2.0 SAFETY LIMITS AND LIMITING SAFETY SYSTEM SETTINGS

NL/91/16

### 3/4.2 POWER DISTRIBUTION LIMITS

FIGURE 3.2.3-1 MCPR<sub>f</sub>

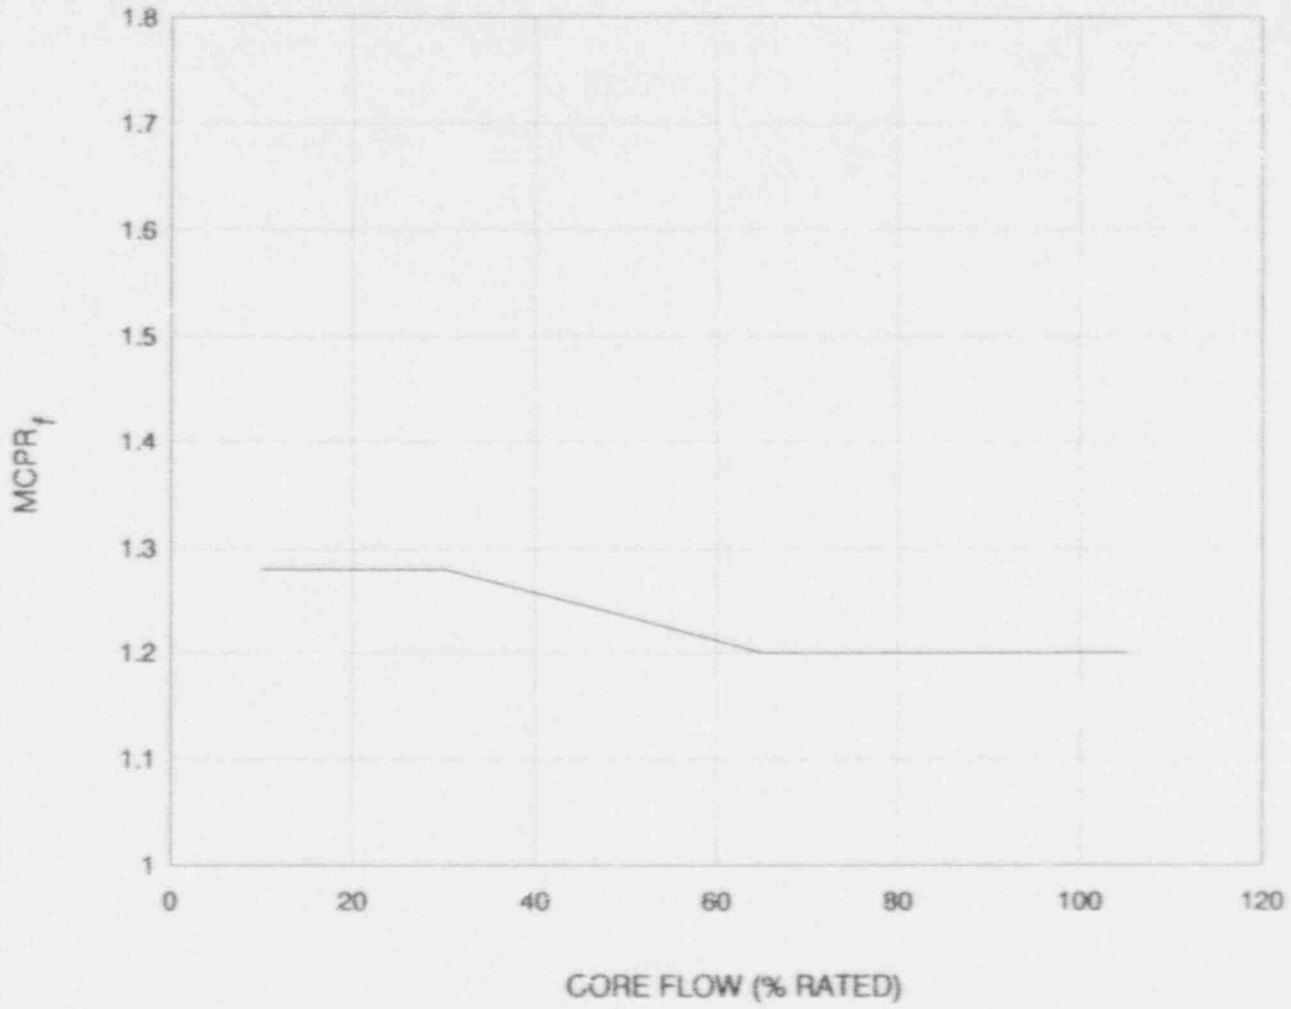
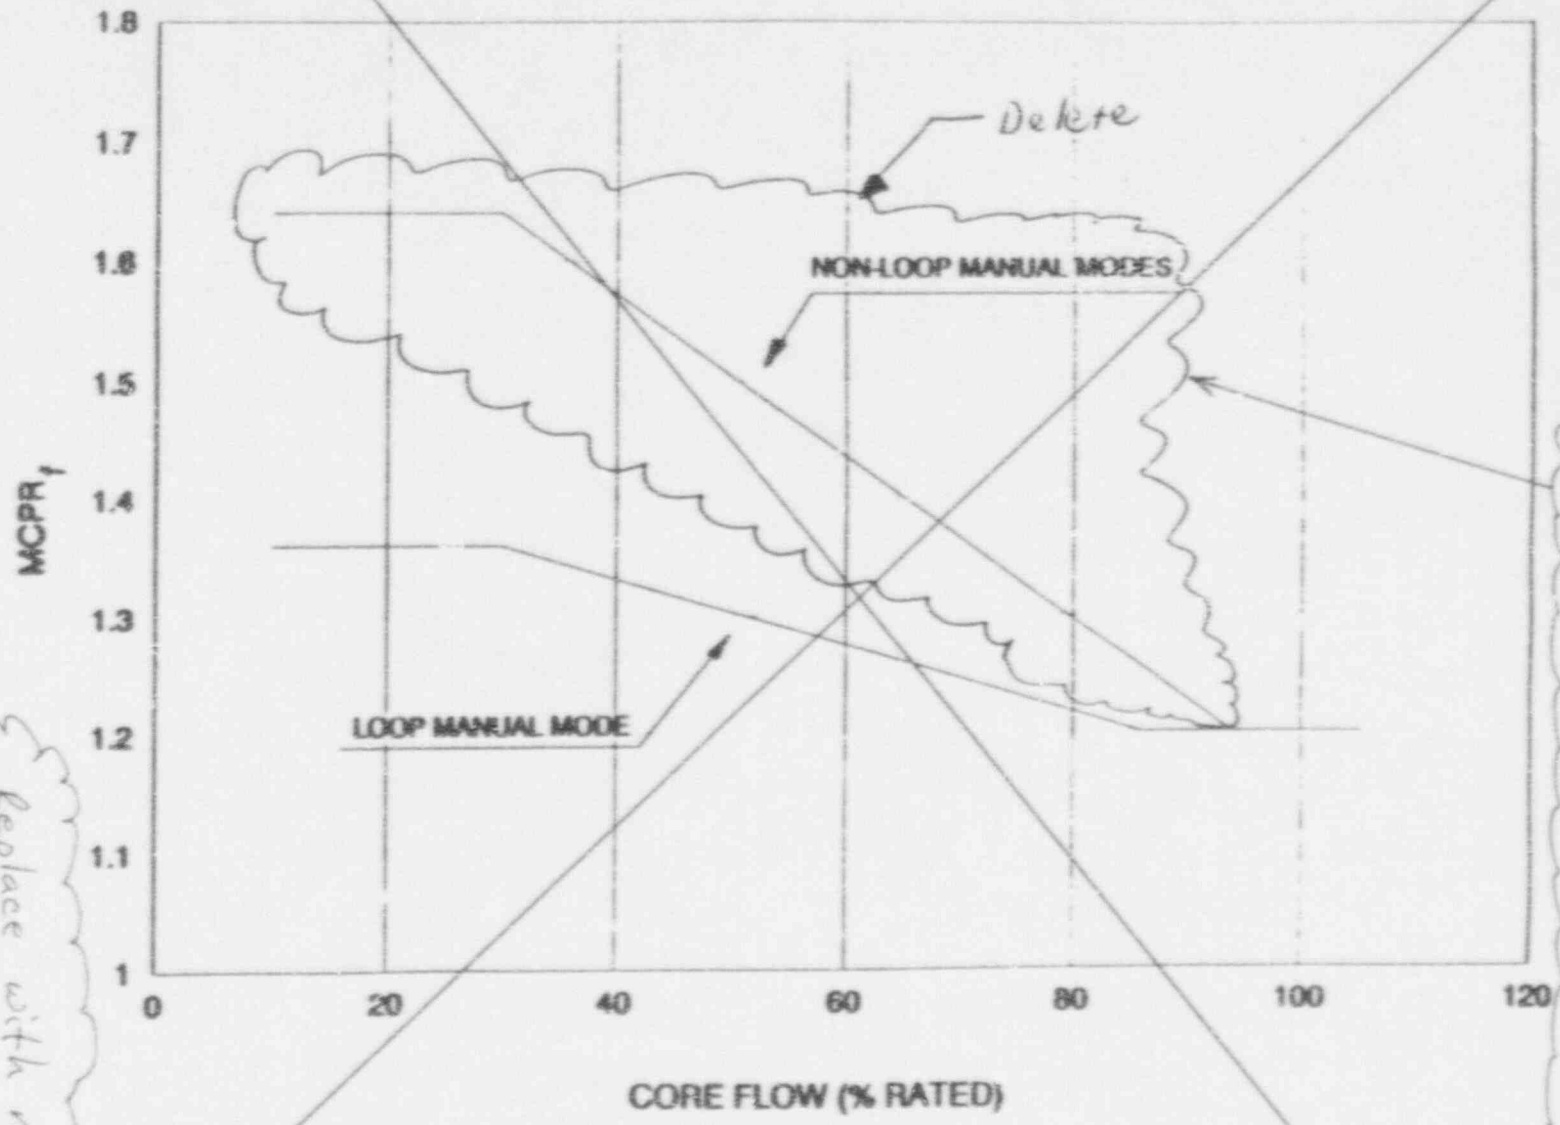
Replace with new Figure 3.2.3-1.

Proposed changes to this figure were previously submitted by G/DCO-91/00071.

FIGURE 3.2.4-2 LHGRFAC<sub>f</sub>

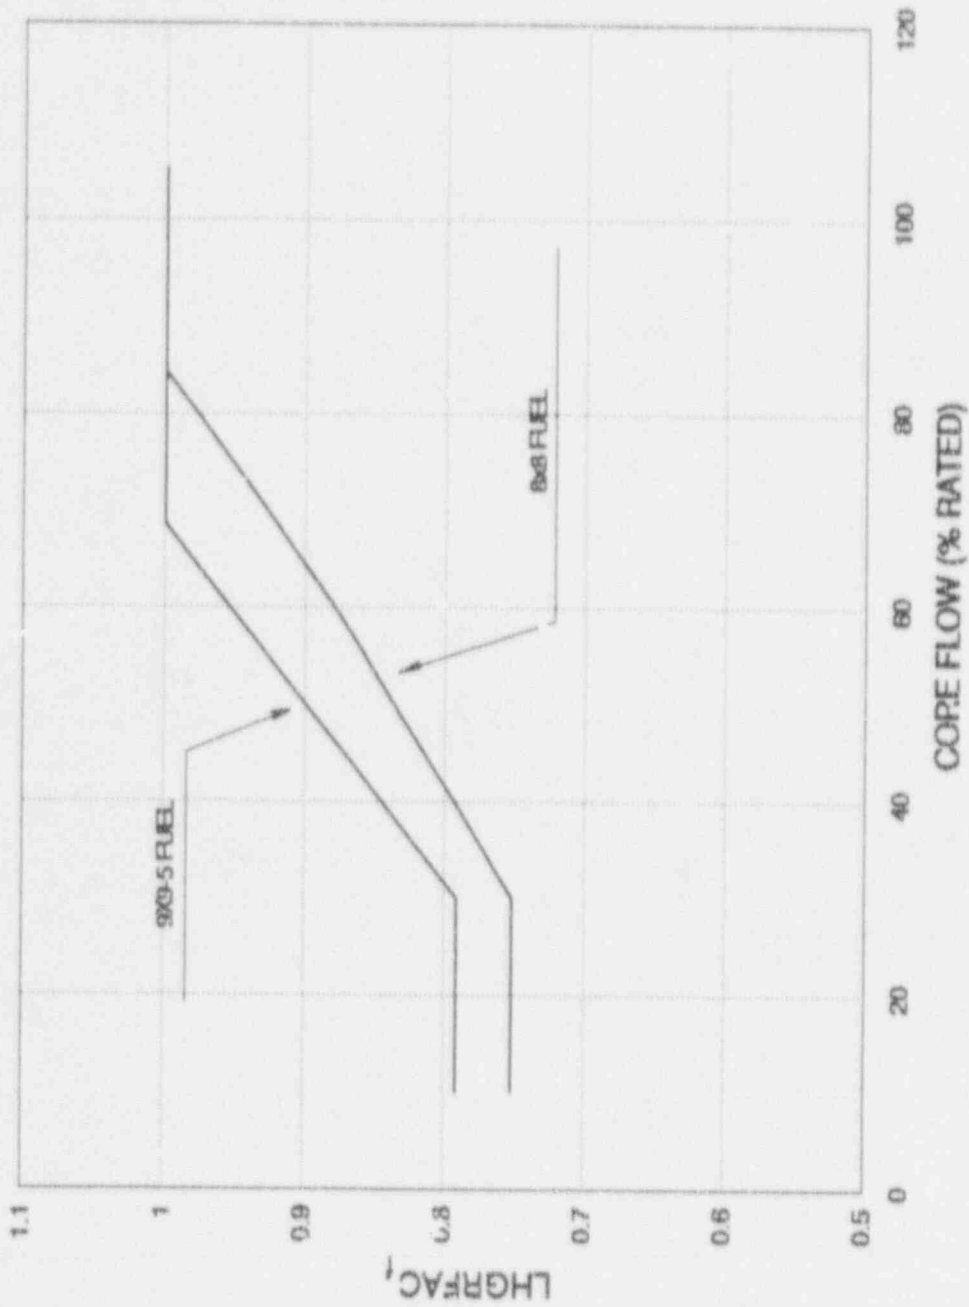
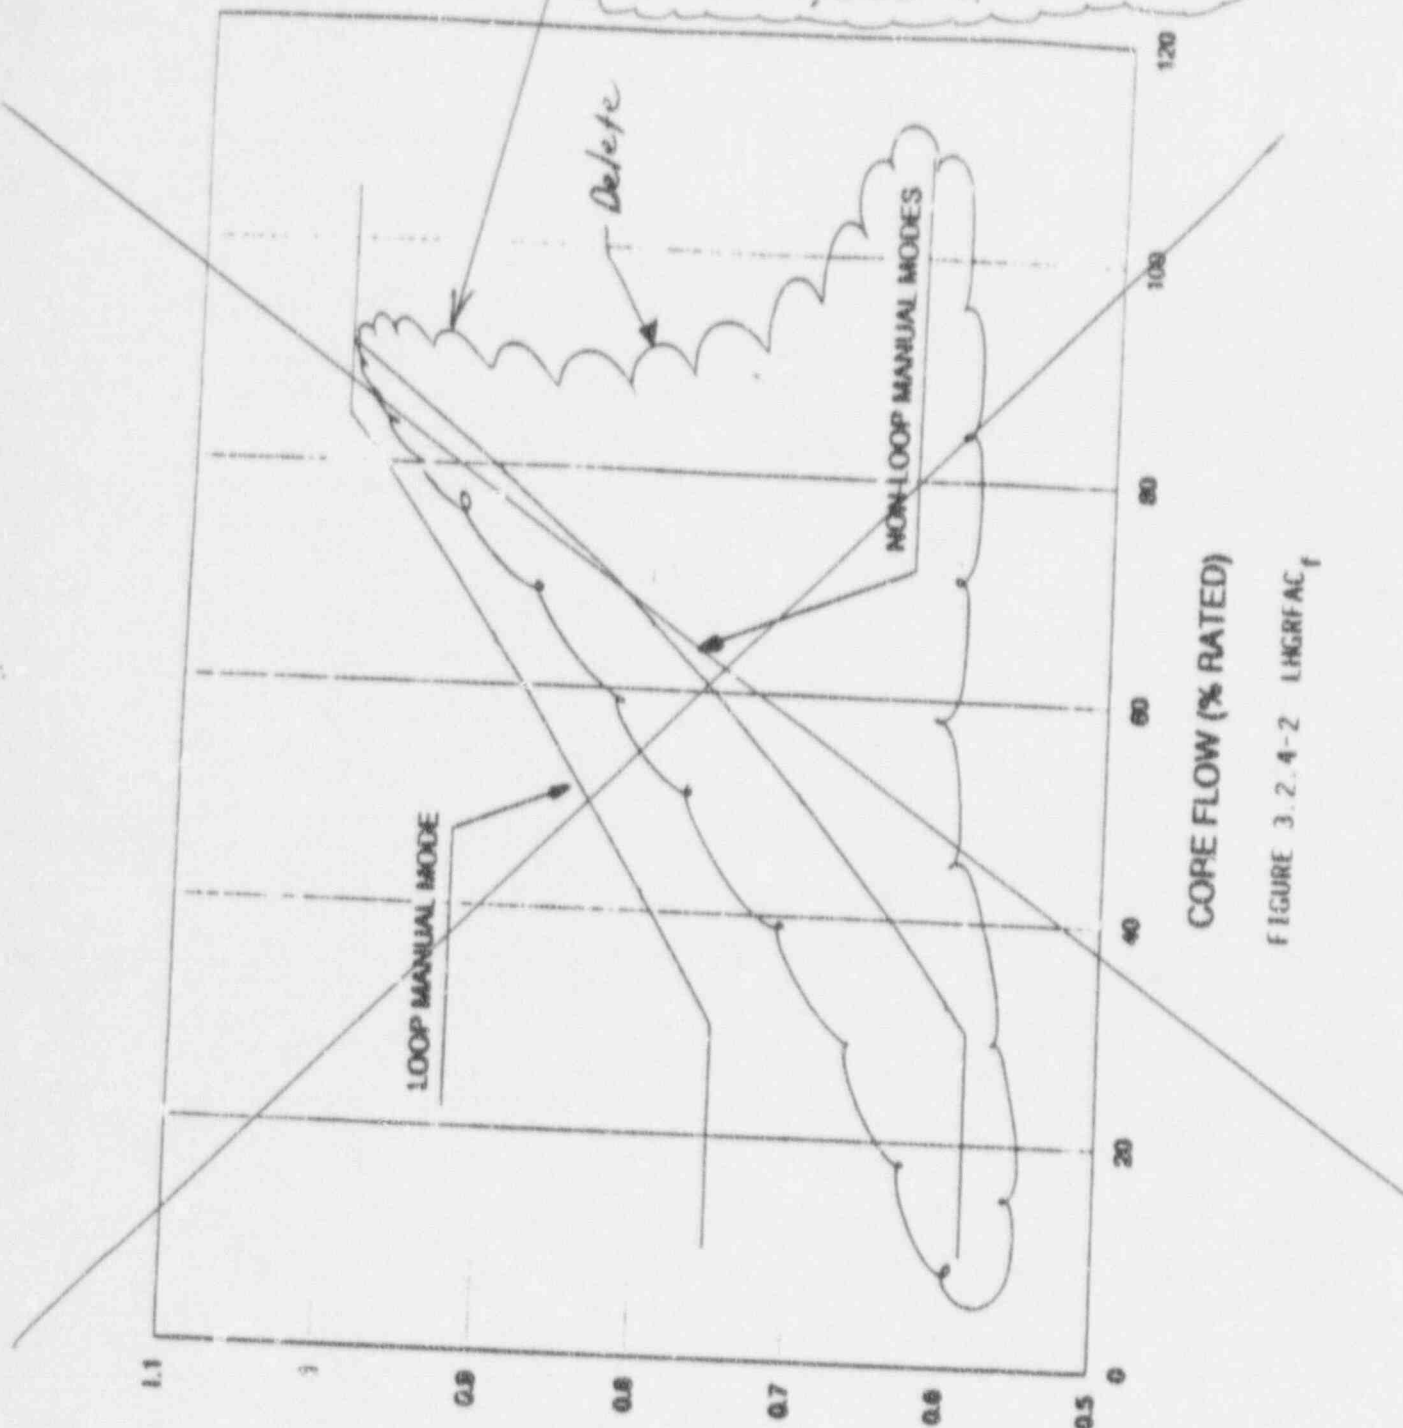
Proposed changes to this figure were previously submitted by GNRO-91/00071.

Replace with new Figure 3.2.4-2
